ADDENDUM NO. 1

CRANDALL ISD – PERFORMING ARTS CENTER ADDITION TO CRANDALL HIGH SCHOOL

AUGUST 26, 2024

39-23712-00
LEVEL 01 - AREA B - FLOOR PLAN

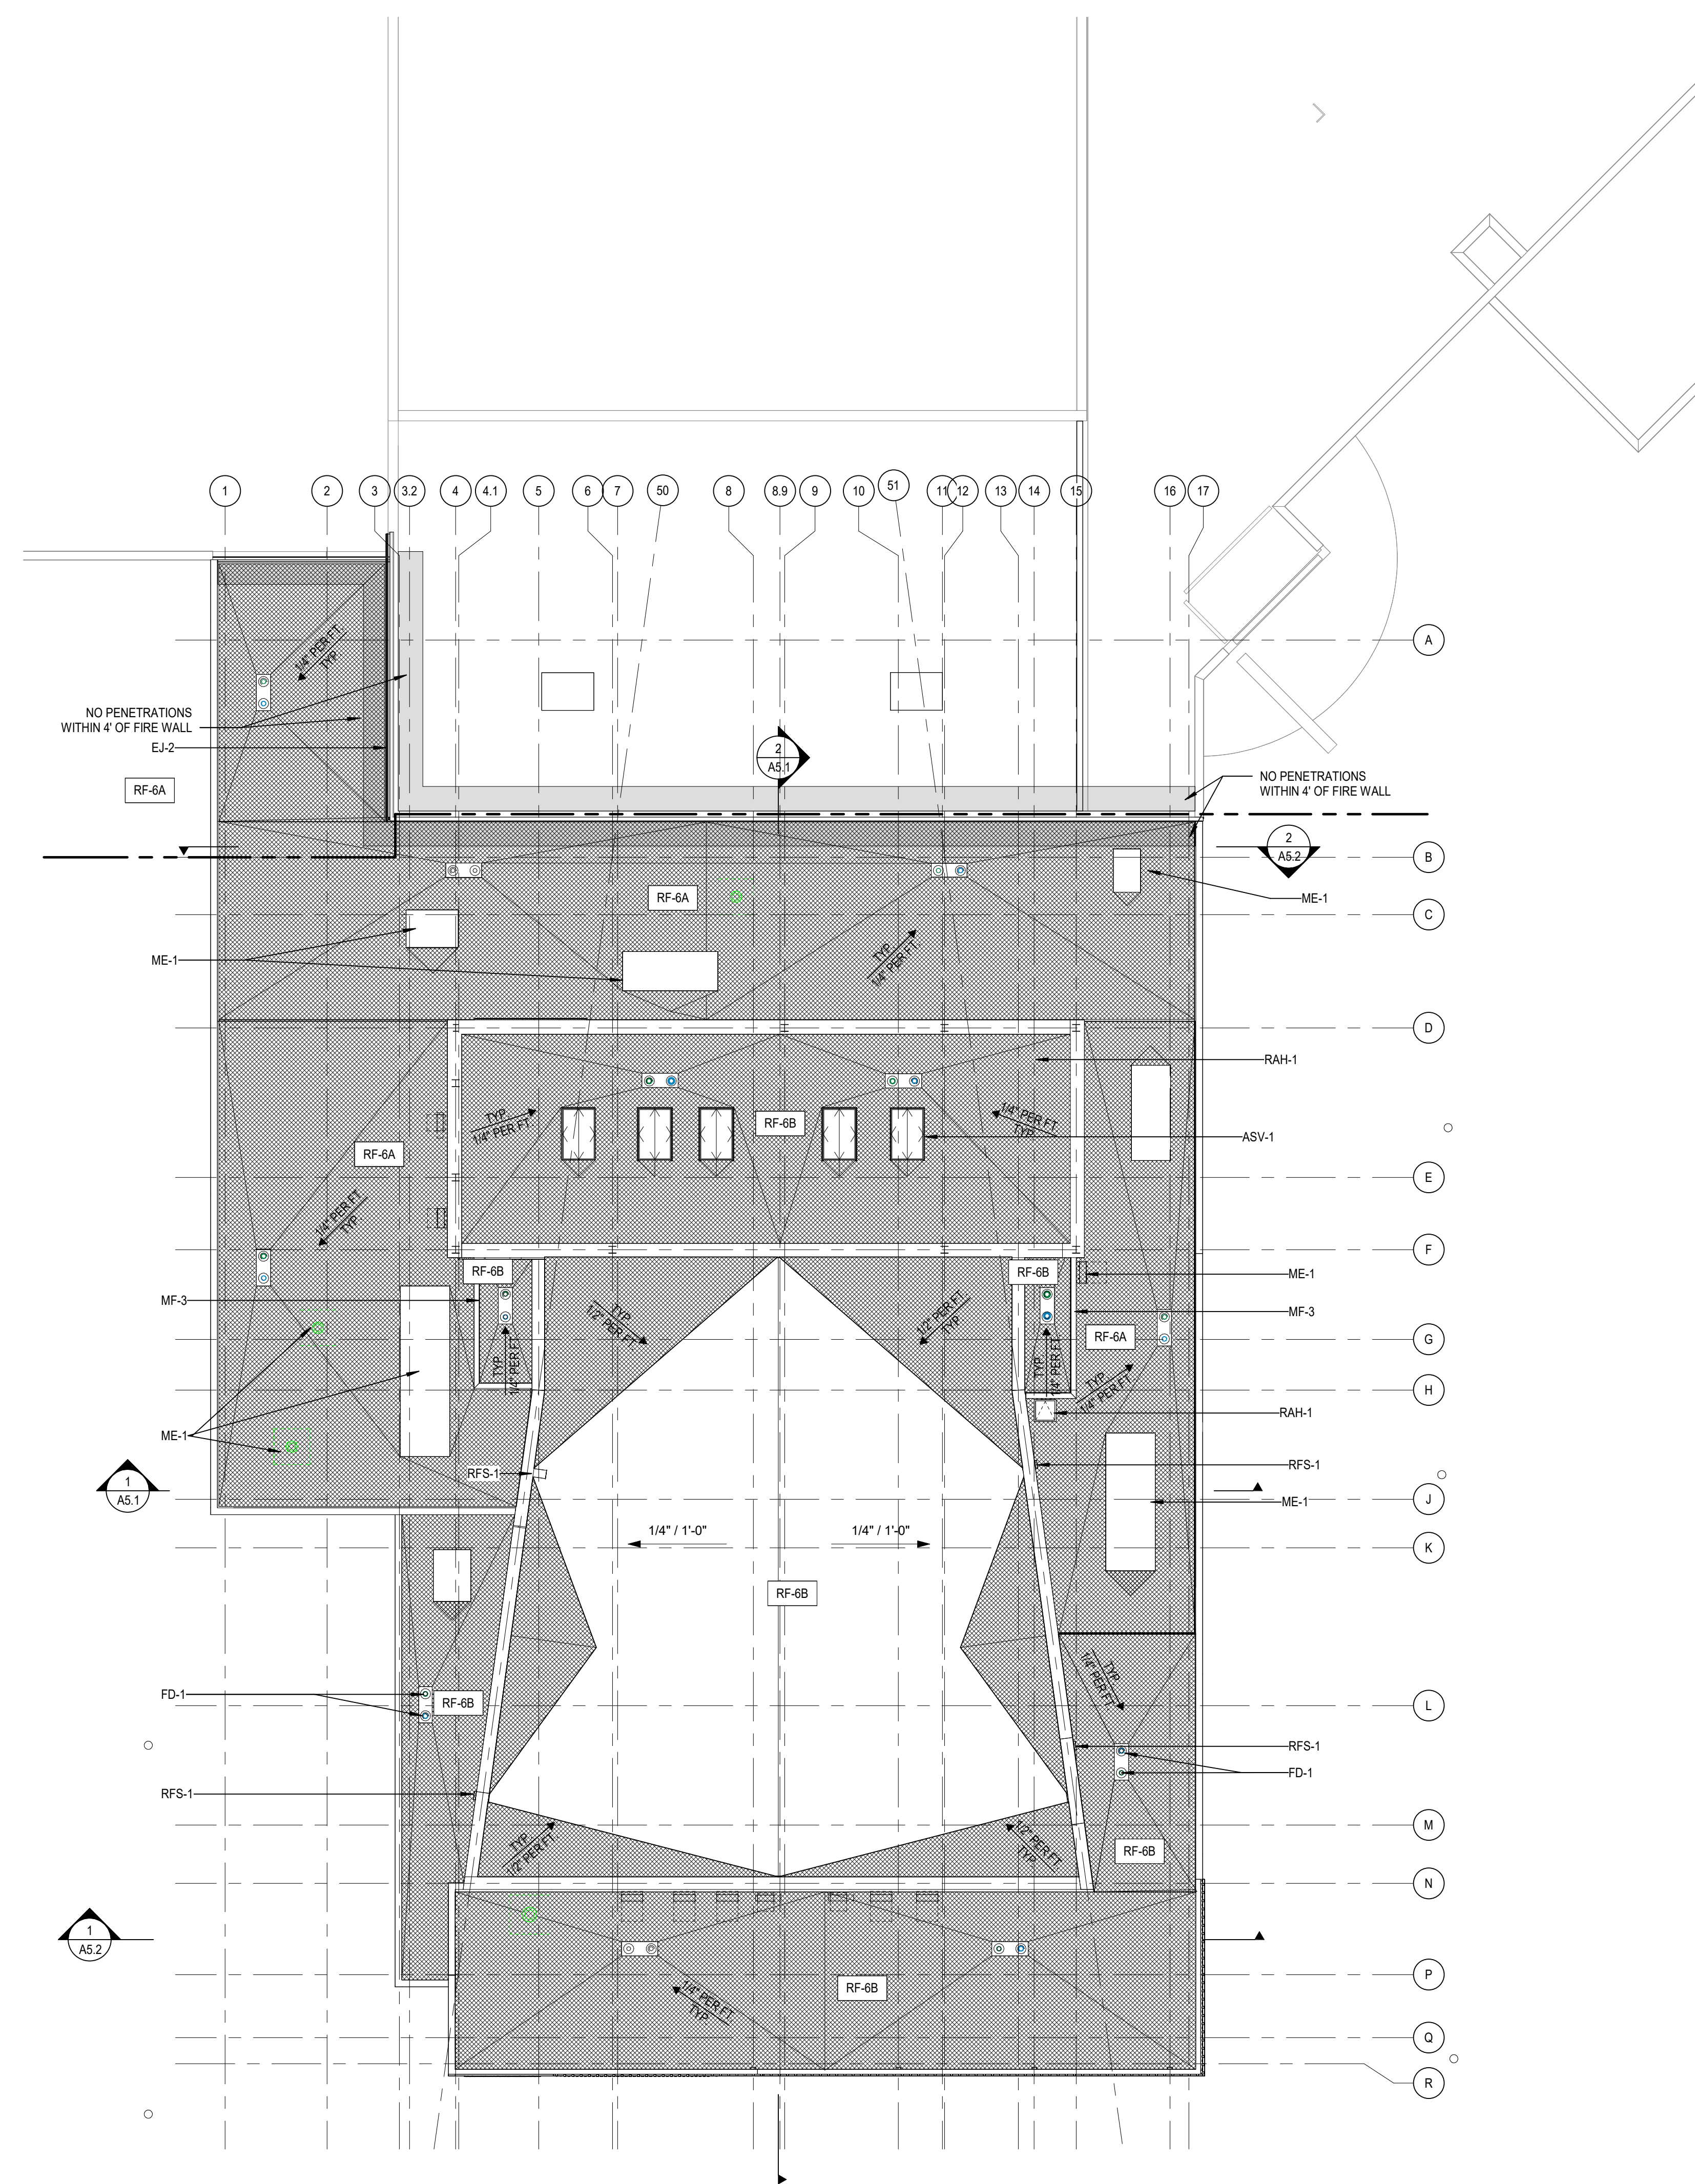
- ITEM 18. A1.1B – LEVEL 01 – AREA B – FLOOR PLAN – Renamed Storage room to change use to Fire Riser Room as indicated on re-issued sheet.
- ITEM 19. A1.4 – OVERALL ROOF PLAN - has been revised as follows and indicated on the re-issued sheet:
